# Evaluation of Physical Barriers - South Perris Station

Address: South Perris Blvd, Perris, CA 92570

Evaluation Date: 08-06-2021

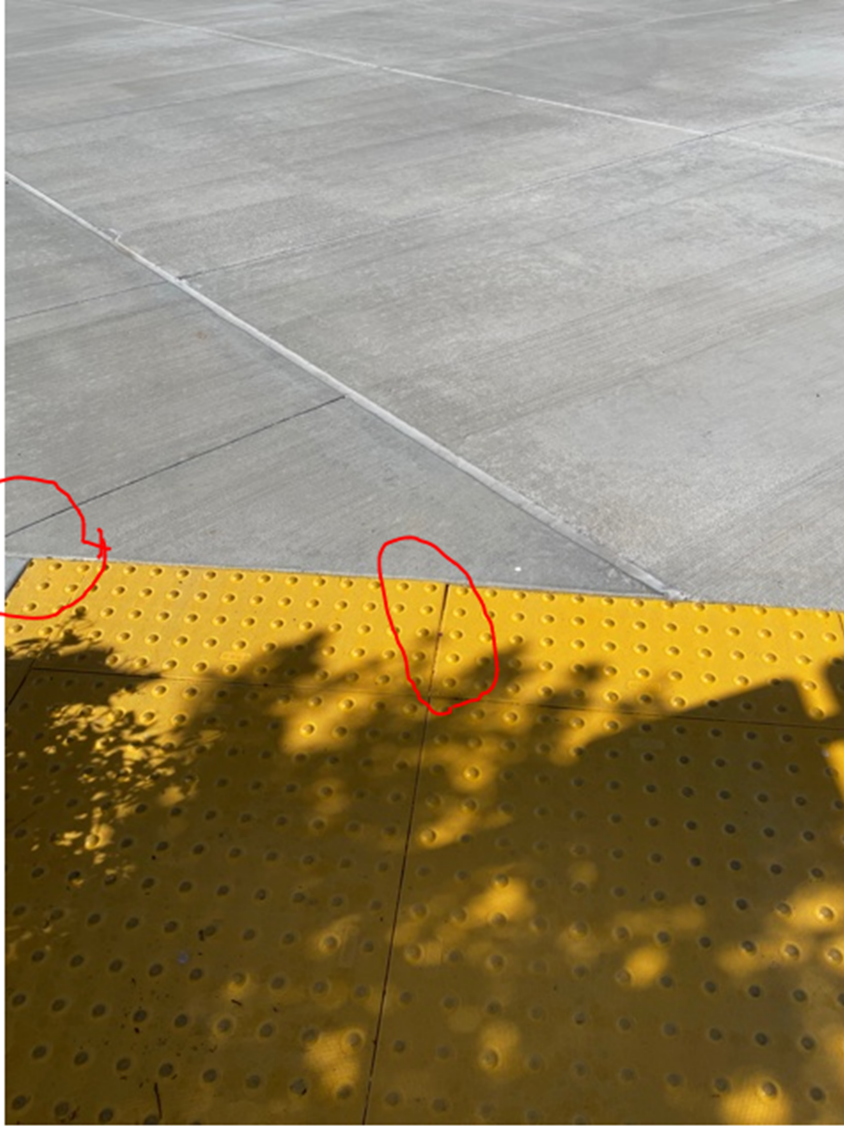
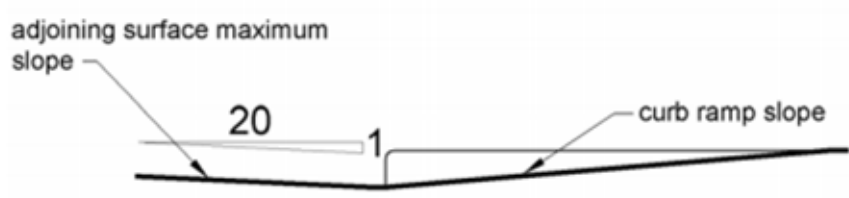
1. Curb ramps (1a, 1b, 1c, 2a, 2b, 2c)
2. Pedestrian road crossings (not applicable)
  - a. Pedestrian push button signals (not applicable)
3. Accessible routes
  - a. Walking surfaces
4. Platforms
  - a. Walking surfaces
  - b. Mini High platforms and ramps
5. Pedestrian rail crossing
6. Access to public amenities
  - a. Ticket Vending/validation machines (TVM),
  - b. Drinking fountain
  - c. Communication Systems- passenger information phones, blue emergency phones, yellow call boxes.
  - d. Trash cans,
  - e. Vending machines
  - f. Benches
7. Accessible parking spaces
8. Bus stops
9. Signage
10. Public Address Systems
11. Staff facilities
  - a. Security Staff Facility
  - b. Dumpster
  - c. Layover Facility (Restricted entry- not able to assess)

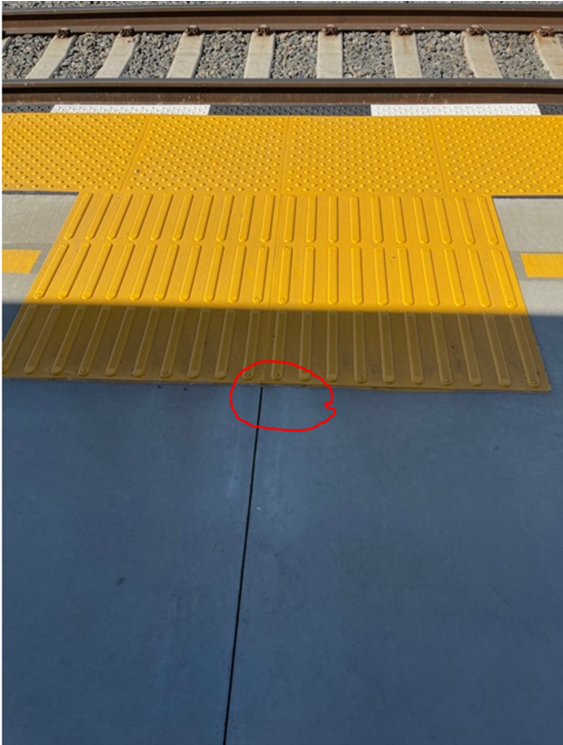
Issues	Recommendations	Comments
<div>1. Curb Ramps</div> <div>1a, 1b, 1c - OK 2a, 2c – OK 2b- Trip hazard due to level change in Detectable Warning Surface (DWS) tile.</div> <div></div>	<div>See Item 3 below</div>	<div>Curb ramps are labeled on page 1</div> <div><p><b>Figure 406.2</b> <b>Counter Slope of Surfaces Adjacent to Curb Ramps</b></p></div> <div>This evaluation does not include curb ramps outside the RCTC boundary. RCTC is not responsible for maintaining the accessible routes outside of RCTC boundary.</div> <div>When repairs begin, use proper and precise instruments (4-foot smart level and 2-foot smart level) to fit within the curb ramp width and the adjacent gutter to measure ramp slopes, cross slopes, and counter slopes at all curb ramps (all stations). The long slope of ramp shall not exceed 1:12 (8.33%). Slope of flared sides shall not exceed 1:10 (10%), the gutter slope shall not exceed 1:20 (5%). Cross slope of the ramp and landing shall not exceed 1:50 (2%)</div> <div>Use smart level instruments, calibrated in accordance with manufacturer’s instructions before taking measurements.</div>

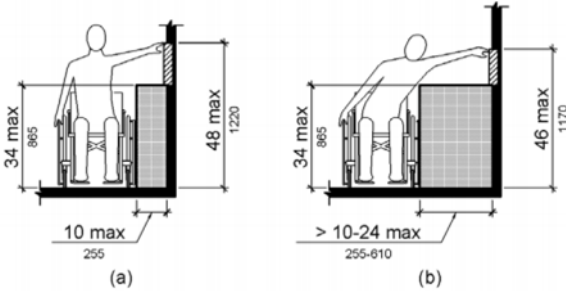
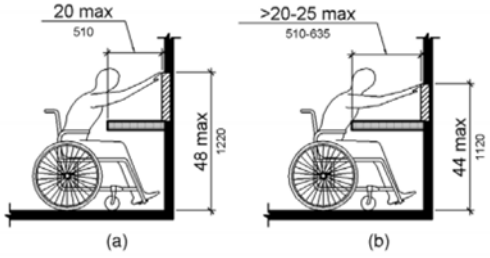
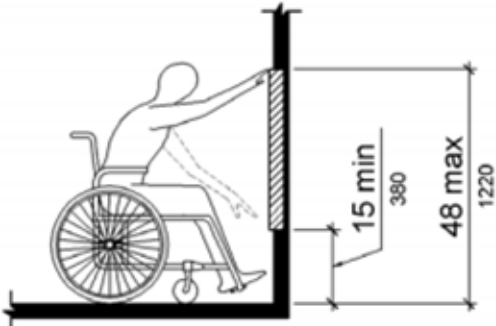
a) Pedestrian Push Button- Not Applicable	No action by RCTC	
<b>3. Accessible Routes</b>		
a) Walking surface		
<p>Aisles at the ADA parking spots have major cracks, level changes, and gaps. The asphalt has separated from the concrete causing gaps wider than an inch. The parking spaces are not accessible due to these issues.</p>  	<p>Examine all parking aisles, accessible routes and repair all cracks.</p> <p>Every joint deeper than <math>\frac{1}{4}</math>" and wider than <math>\frac{1}{2}</math>" shall be filled.</p> <p>Every level change along the accessible route greater than <math>\frac{1}{4}</math>" and less than <math>\frac{1}{2}</math>" height needs to be beveled (1:2) slope or repaired.</p> <p>Every level change greater than <math>\frac{1}{2}</math>" needs to have a ramped surface (1:12) slope.</p>	 <p>Figure 302.3 Elongated Openings in Floor or Ground Surfaces</p>  <p>Figure 303.3 Beveled Change in Level</p>  <p>Figure 303.2 Vertical Change in Level</p>

<p>Cracked concrete at drop off zone.</p> 	Same as above
